RE: Comments Sabey Data Center

Please accept my comments regarding the proposed addition of 19 diesel engines at the Sabey Data Center. Because I have a number of concerns, I will itemize them so that you can respond in kind.

Fig. 3

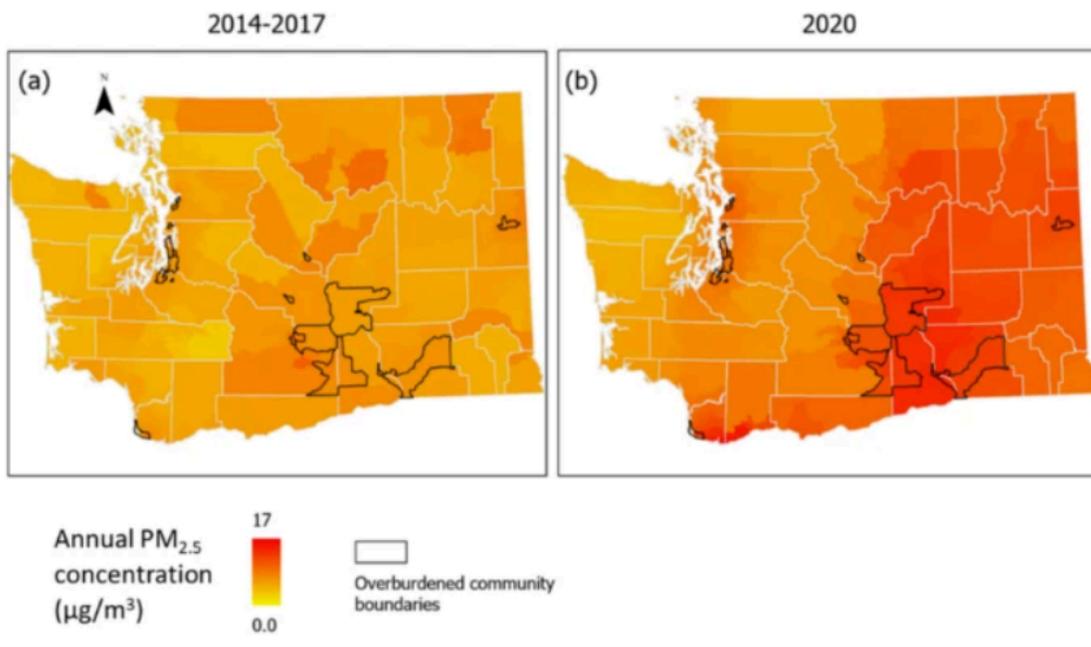
PM_{2.5} Background Levels are higher than cities in Western Washington. Ultra fine particulate matter triggers cardiovascular, respiratory and other health affects, and disproportionately impacts communities of color like Quincy. According to the EJScreen, Quincy is in the 92nd percentile for PM_{2.5}. Adding to the community’s burden by permitting additional uncontrolled diesel engines is irresponsible, especially from an agency charged with protecting human health.
